TRANSMITTAL OF CHANGE PAGES TO THE FINAL INTEGRATED REMEDIAL DESIGN PACKAGE FOR THE AREA 6 SOLID WASTE LANDFILL AND FIRE TRAINING FACILITY

**IMPLEMENTATION PLAN FOR
AREA 6 SOLID WASTE LANDFILL
AND FIRE TRAINING FACILITY**

**20600-PL-0003
REVISION 0
PCN 1**

<u>Revision</u>	<u>Date</u>	<u>Description of Revision</u>
Rev. 0	3/31/03	Initial controlled issuance.
PCN 1	9/15/03	Revised Figure 2-5 and Section 2.6.1 to provide additional detail of the above-WAC uranium bounding in the SWL and correct the bounding depth from 18 feet to 7 feet.

FIGURE 2-5. CROSS-SECTION OF SWL REMEDIAL EXCAVATION

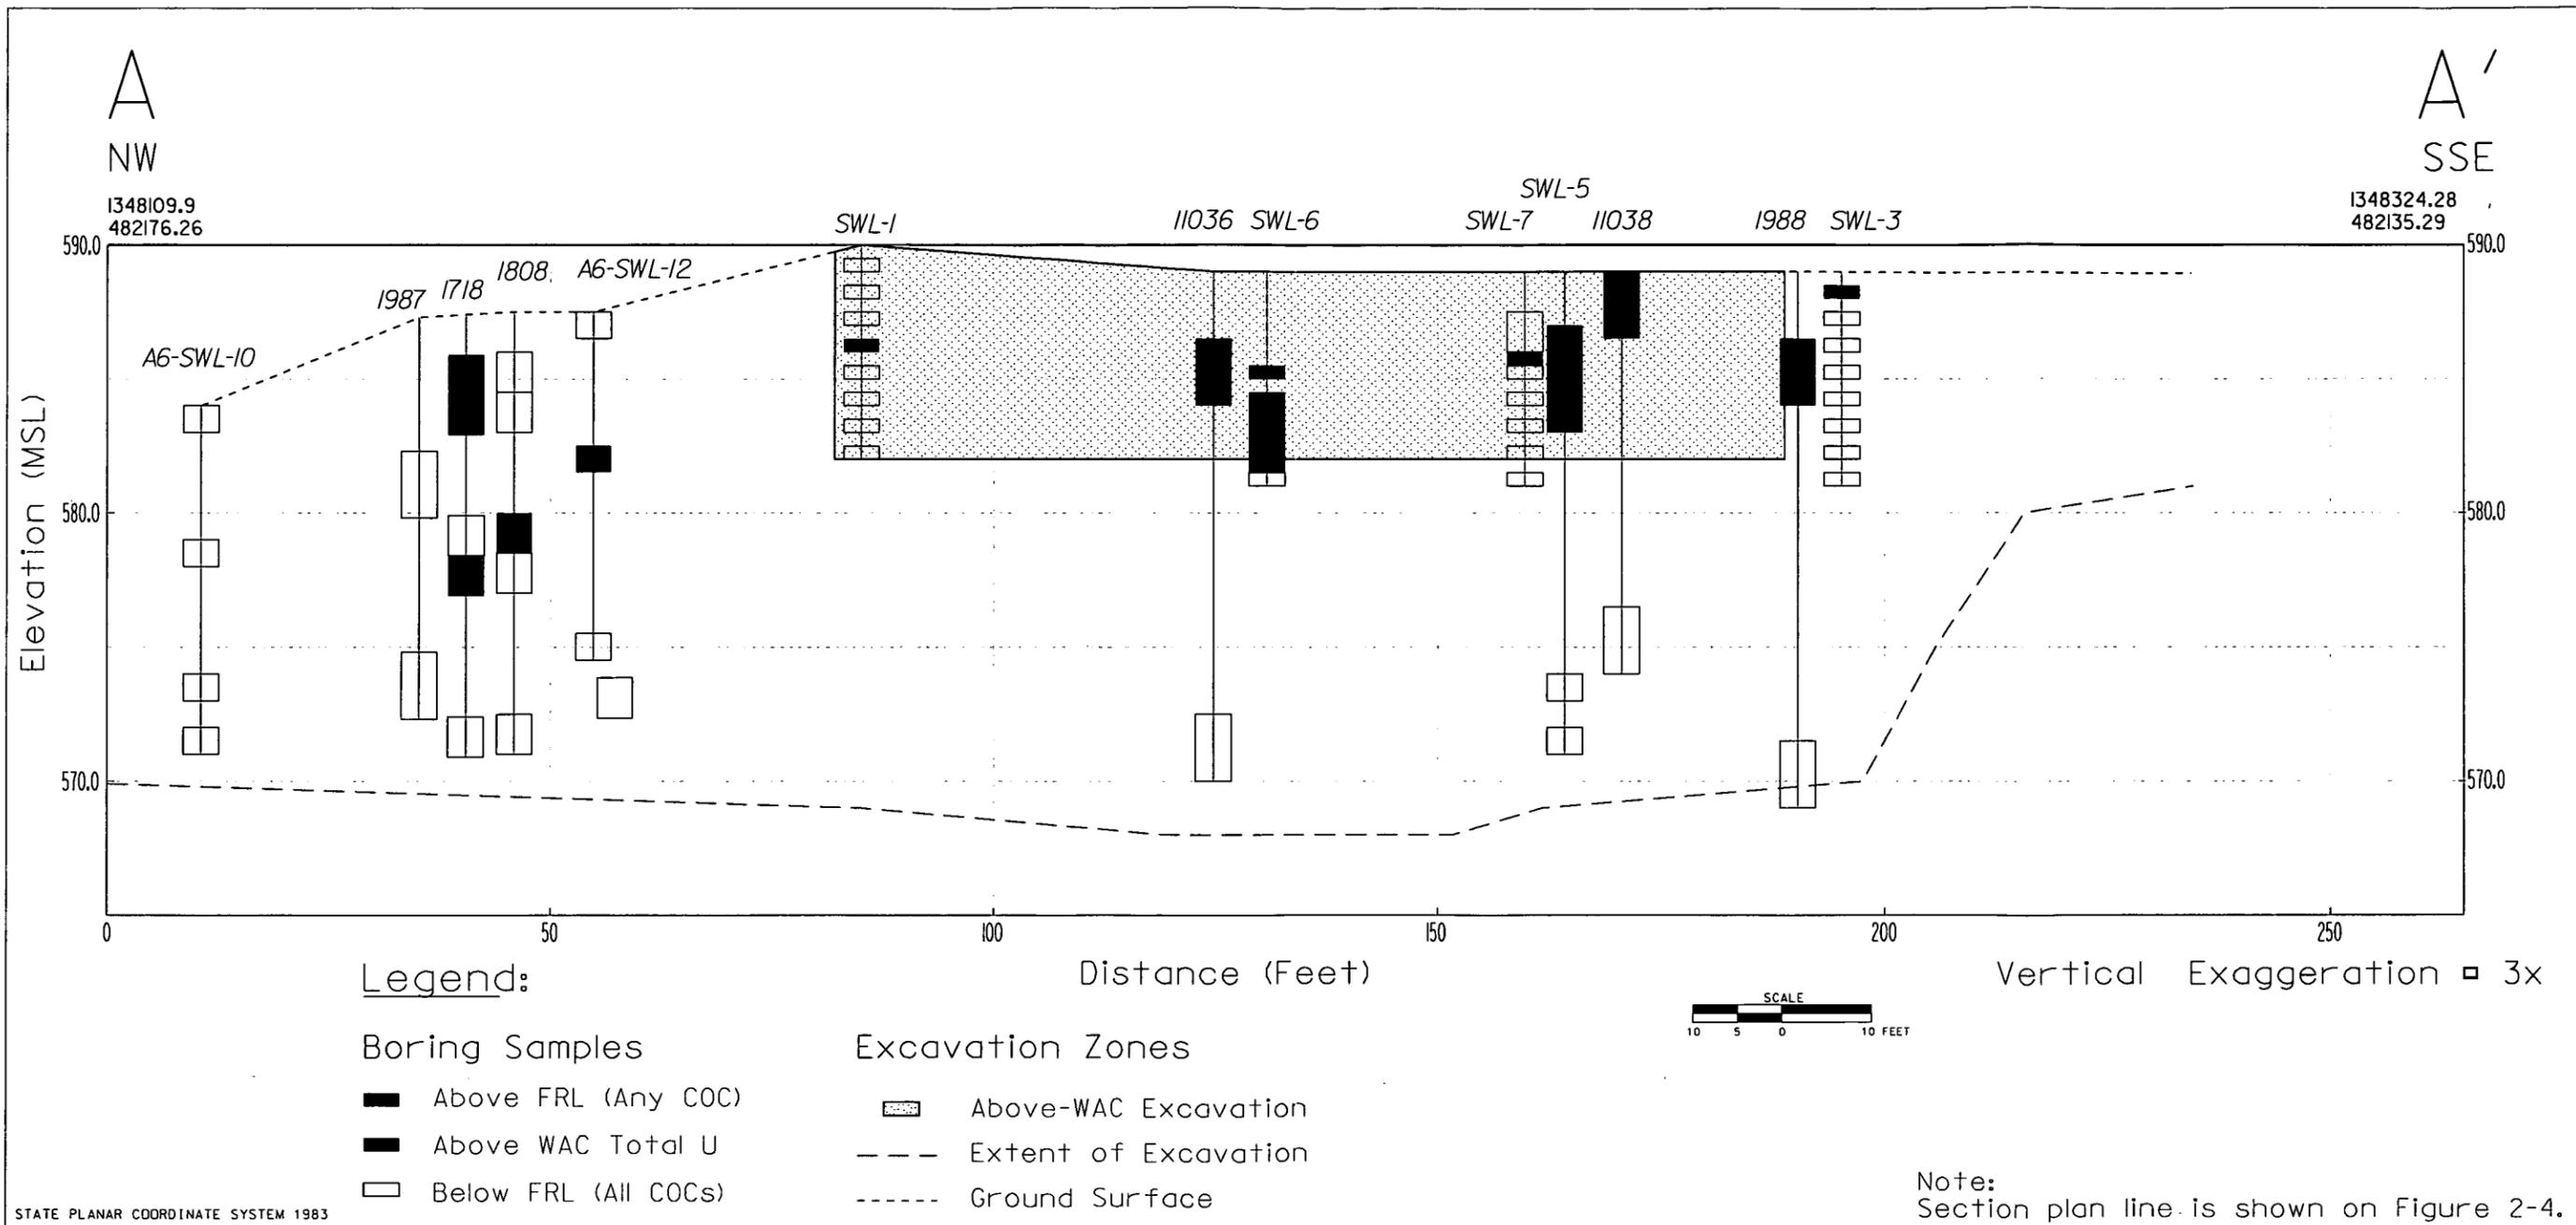
Enclosed for your approval are page changes to the final Integrated Remedial Design Package for the Area 6 Solid Waste Landfill (SWL) and Fire Training Facility. These page changes include revised text in Section 2.6.1 to provide additional detail of the above Waste Acceptance Criteria (WAC) uranium bounding in the SWL and to correct the depth of the bounding from 18 feet to 7 feet as shown in revised Figure 2-5.

PCN 1 A review of the historical data set identified total uranium present in the subsurface at above-WAC levels at three RI/FS borings; 11036 (1170 ppm), 1986 (1280 ppm), and 1722 (1247 ppm). Lateral bounding was achieved with borings SWL-1 through 5 and vertical bounding to a maximum depth of 7.0 feet was achieved with boring SWL-6. The excavation volume was determined based on a straight wall excavation at bounding points SWL-1, 2, 3, 4, and 5. The above-WAC design excavation depths are shown on the SWL and FTF Grading/Drainage Plan (SWL) drawing included with this IRDP. A cross section of the SWL remedial excavation, including the above-WAC area, is shown on Figure 2-5.
